BVY 15-009

SUBJECT: Vermont Yankee Permanently Defueled Emergency Plan and Emergency Action Level Scheme - Supplement 2 (TAC No. MF4279)  
Vermont Yankee Nuclear Power Station  
Docket No. 50-271  
License No. DPR-28

Vermont Yankee Nuclear Power Station  
Response to Request for Additional Information

**REQUEST FOR ADDITIONAL INFORMATION  
REGARDING AMENDMENT REQUEST FOR  
PERMANENTLY DEFUELED EMERGENCY PLAN CHANGE  
ENTERGY NUCLEAR OPERATIONS, INC.  
VERMONT YANKEE NUCLEAR POWER STATION  
DOCKET NO. 50-271**

**Figure 9.1**  
**Notification Plan**

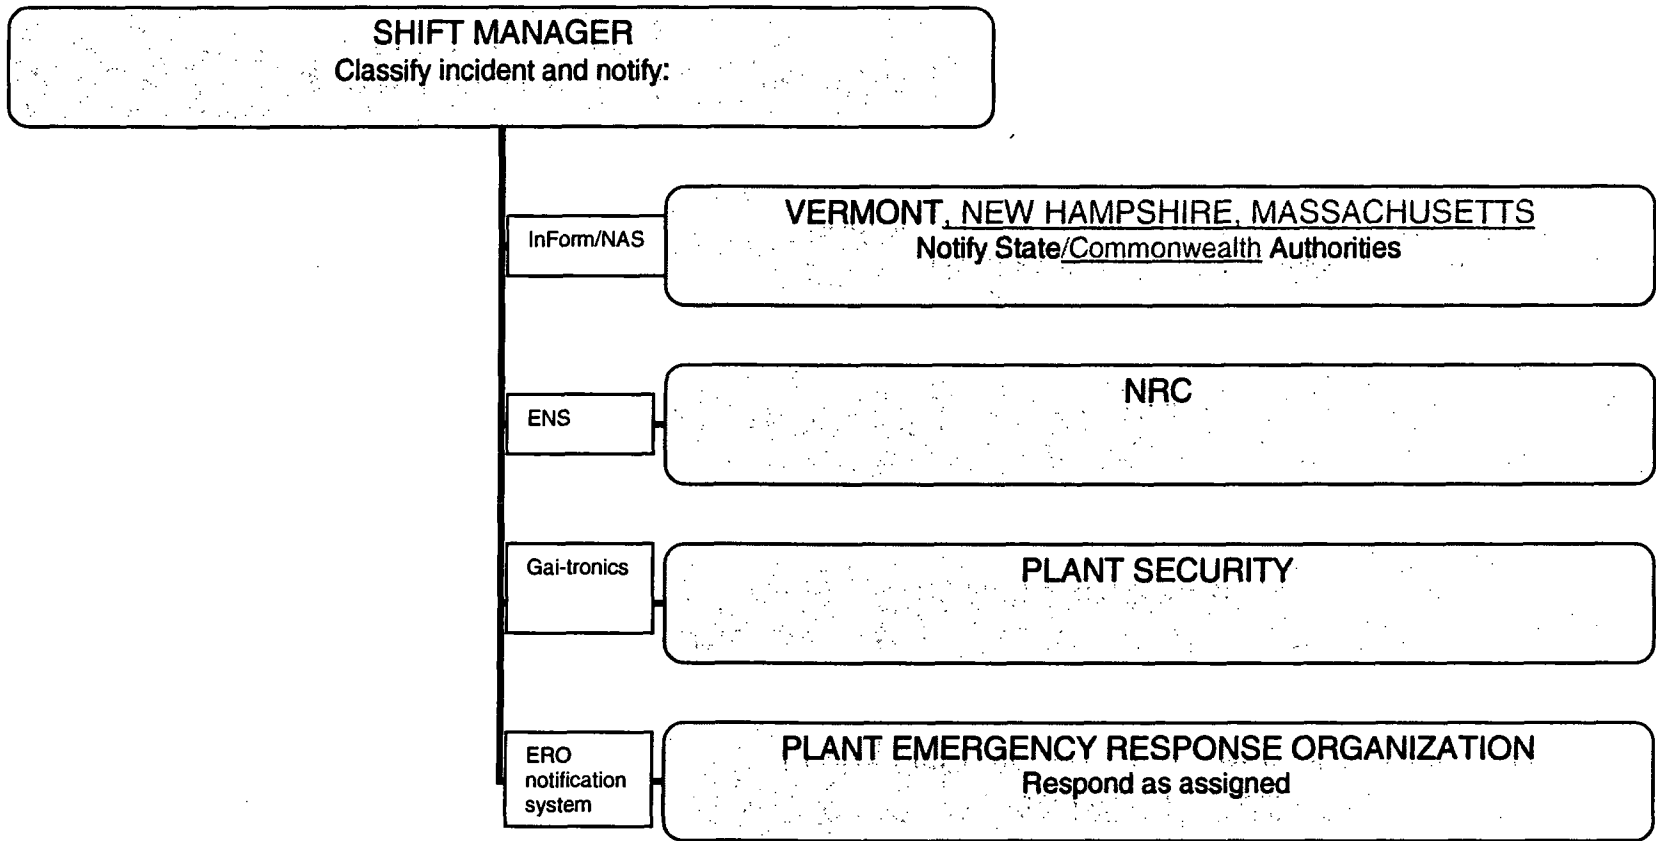
**Sections 3.1, "Overview of Permanently Defueled Emergency Plan" and 3.6, "State and Local Government Notification and Response" of the PDEP provide no reference to interfaces with the State of New Hampshire and the Commonwealth of Massachusetts. Please provide documentation that the State of New Hampshire and the Commonwealth of Massachusetts have agreed that they no longer require notification from the VY in the event of a declared emergency or revise to address these notifications. Notification of other contiguous States also needs to be addressed in Section 3.3(5) and Figure 9.1, "Notification Plan" of the PDEP.**

Sections 3.1, 3.3 (Item #5), 3.6, 5.2, 5.3, 7.1, 7.2, 8.1.1 (Item #1), 8.3, 9.2.1 (Item #3), 11.1, 12.1.2, Table 7.1, Figure 9.1 and Appendix D (Letters of Agreement) of the PDEP have been revised to address the capability to communicate with and notify New Hampshire and Massachusetts of an emergency declaration.
